ALERT SERVICE BULLETIN

NO. 427-03-09

SUBJECT: TAIL ROTOR GEARBOX CASE P/N 406-040-406-109 OIL FEED PASSAGE, PRESENCE OF AND ADDITION OF.

HELICOPTERS AFFECTED: Model 427 helicopters serial number 56001 through 56031 and 58001 through 58002.

Figure 1. Location of part number and oil feed passage.

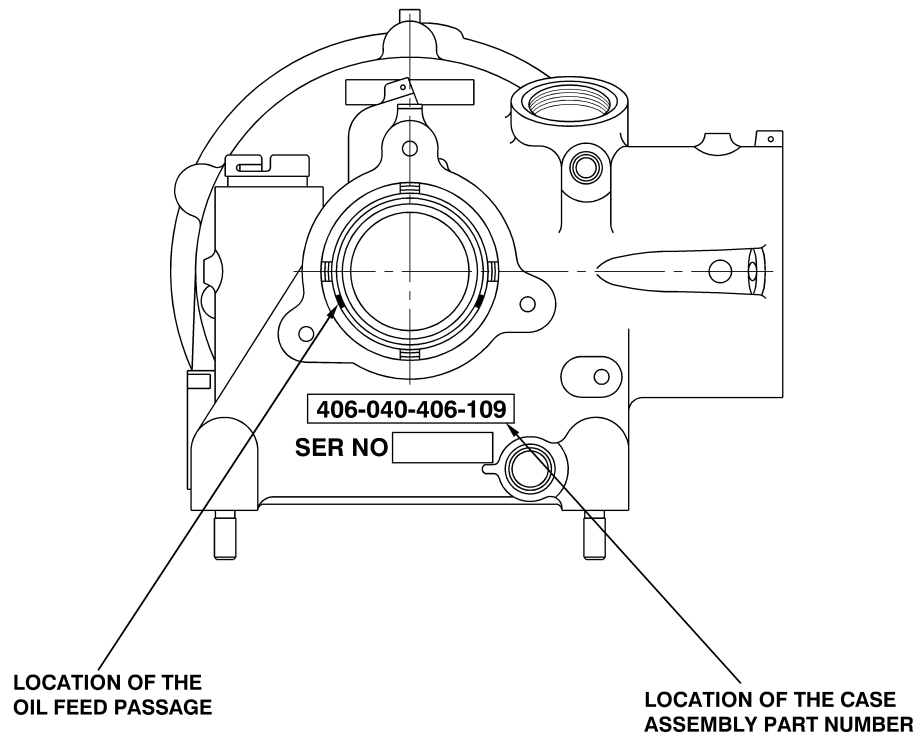
1. Refer to figure 1. Disassemble gearbox (BHT-427-CR&O) and identify the dash number for the gearbox case assembly.
 - a. If the case number is not a P/N 406-040-406-109 then the intent of this bulletin is already incorporated. Continue to step 3.
 - b. If the case number is P/N 406-040-406-109, continue with step 2.
2. Check for the presence of the oil feed passage. Refer to figure 1 for the location of the oil feed passage.
 - a. If the case has an oil feed passage then the intent of this bulletin has been incorporated. Using a vibrating stylus, re-identify the case as a **P/N 406-040-406-109FM**.
 - b. If the oil feed passage is missing, do part II of the ACCOMPLISHMENT INSTRUCTIONS.
3. Continue with Inspection and Reassembly as per BHT-427-CR&O.
4. Make an entry in component and helicopter technical records to show compliance with part I of this bulletin.

Figure 2. Rework of tail rotor gearbox case.

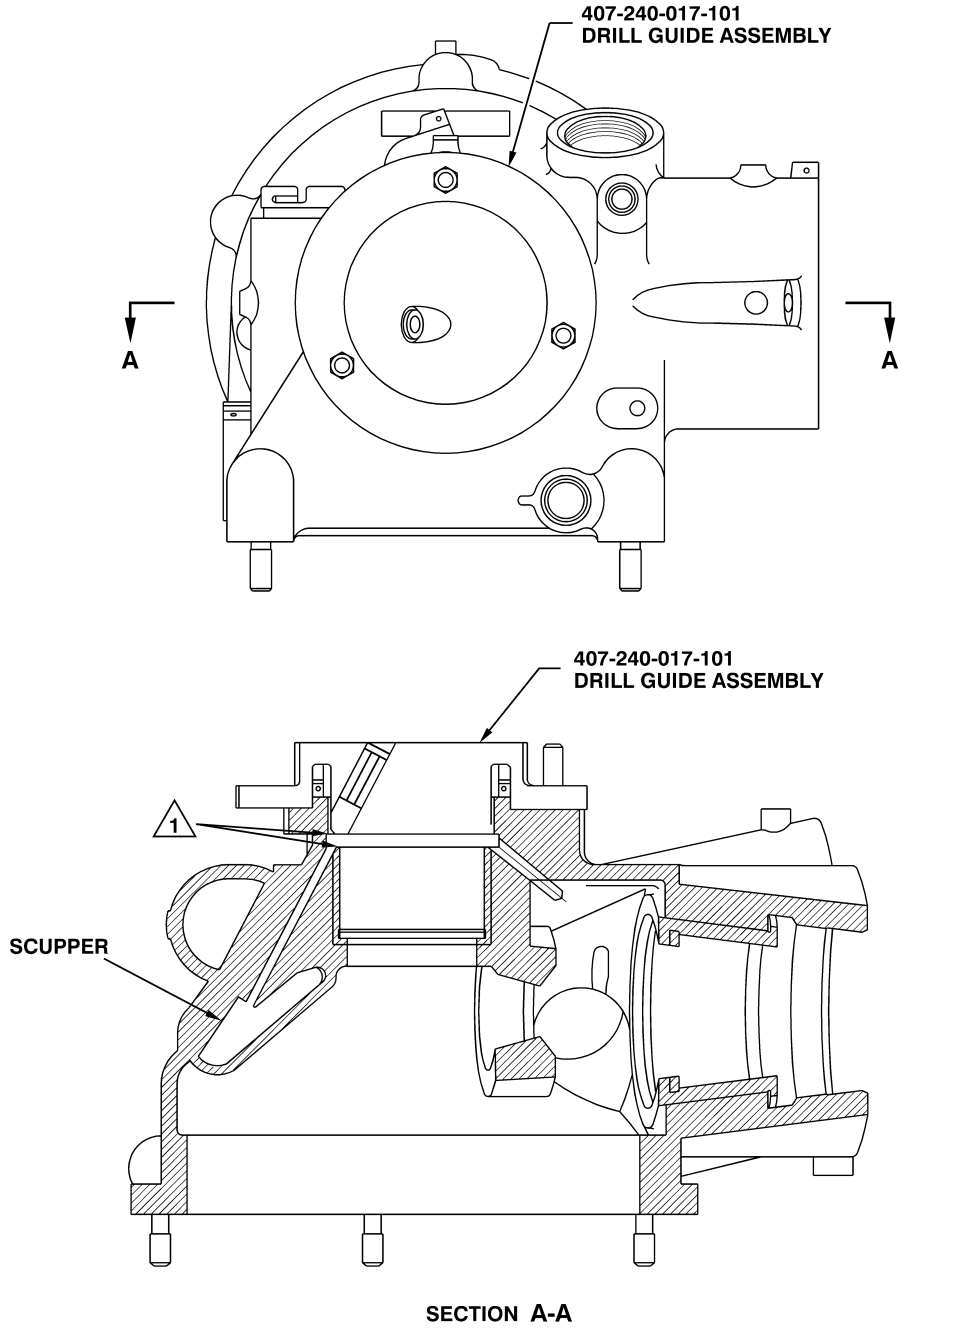
1. Refer to figure 2. Clean affected tail rotor gearbox case P/N 406-040-406-109.. Make sure that paint or sealant is fully removed from the gearbox surface that mates with the drill guide.

2. Install the drill guide tool P/N 407-240-017-101 on gearbox case and attach with the existing hardware.

3. Position and set a drill stop 4.50 +/- 0.030 inches from the point of a short fluted twist drill bit. Lubricate with cutting oil and drill the oil feed passage in the gearbox case.

- 1 Duplex bearing liner can be nicked as the gallery is drilled. This is not detrimental to the liner. Use a Swiss file and remove sharp edges.

4. Remove the drill guide P/N 407-240-017-101.
5. De-burr the sharp edges of the hole.
6. Clean the gearbox case. Make sure that no unwanted material stays in the cavities.
7. Apply corrosion preventative (DOW #19) (C-103) to reworked area. Refer to BHT-ALL-SPM chapter 3.
8. Using a vibrating stylus, re-identify the case as **P/N 406-040-406-109FM**.
9. Continue with inspection/overhaul and re-assemble gearbox using new P/N 406-040-432-103 bearing. Refer to BHT-427-CR&O chapter 65.
10. Make an entry in the component and helicopter technical records to show compliance with part II of this bulletin.
